Westinghouse BWR ECCS Evaluation Model:
Supplement 5 – Application to the ABWR

May 2014

SUBJECT: FINAL SAFETY EVALUATION FOR SOUTH TEXAS PROJECT WCAP-17116-P,
“WESTINGHOUSE BWR ECCS EVALUATION MODEL: SUPPLEMENT 5 –
APPLICATION TO ABWR”

Figure 19-1 – Variation of Maximum Cladding Temperature During Partial Core Uncovery with Respect to Bundle Peaking Factor

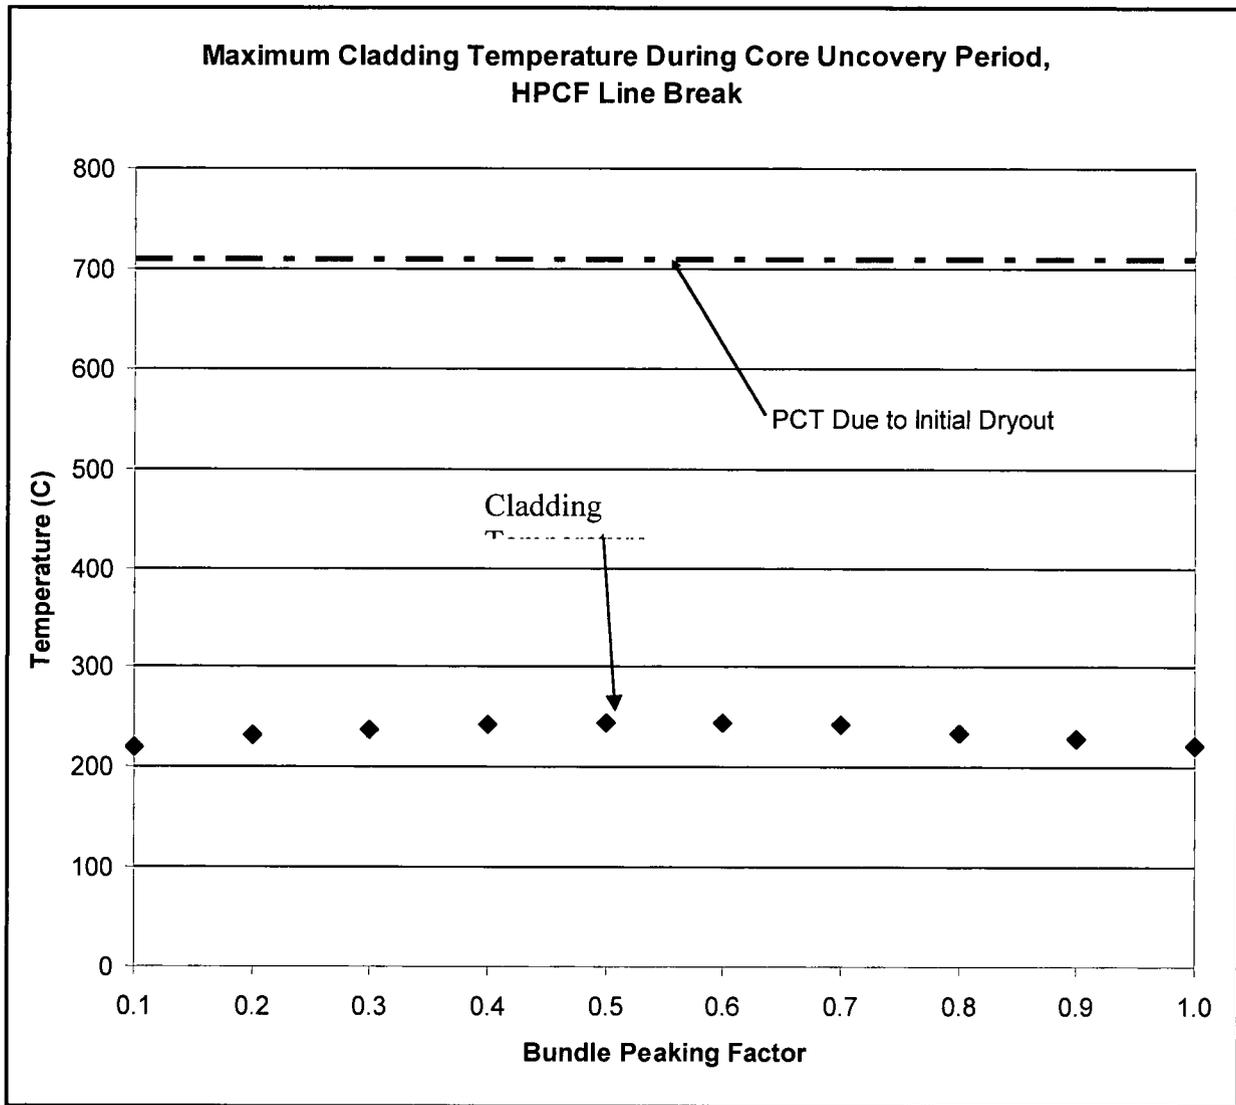
As a result of this RAI response, Section 4.7 of WCAP-17116-P will be revised as shown in the markup attached to the response to RAI 32 Supplement 2. Changes from Revision 0 are highlighted with gray shading.
